## **SCREENING AND SCOPING OPINION UNDER THE MARINE WORKS (ENVIRONMENTAL IMPACT ASSESSMENT) REGULATIONS 2007 (as amended)**

### **WAVE DRAGON WALES**

### Scoping Opinion (SC1812)

Figure 1 Proposed location

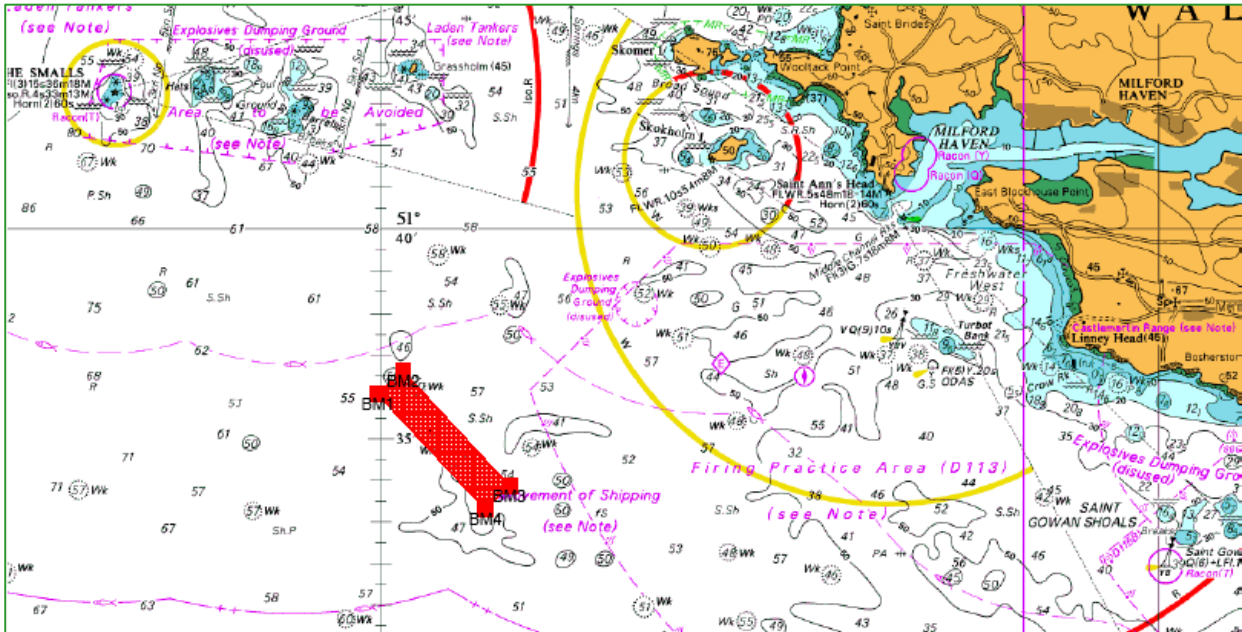
4.1. The planned site location overlaps with a Welsh Marine Plan Shipping Strategic Resource Area (SRA). You must demonstrate how the two can co-locate.
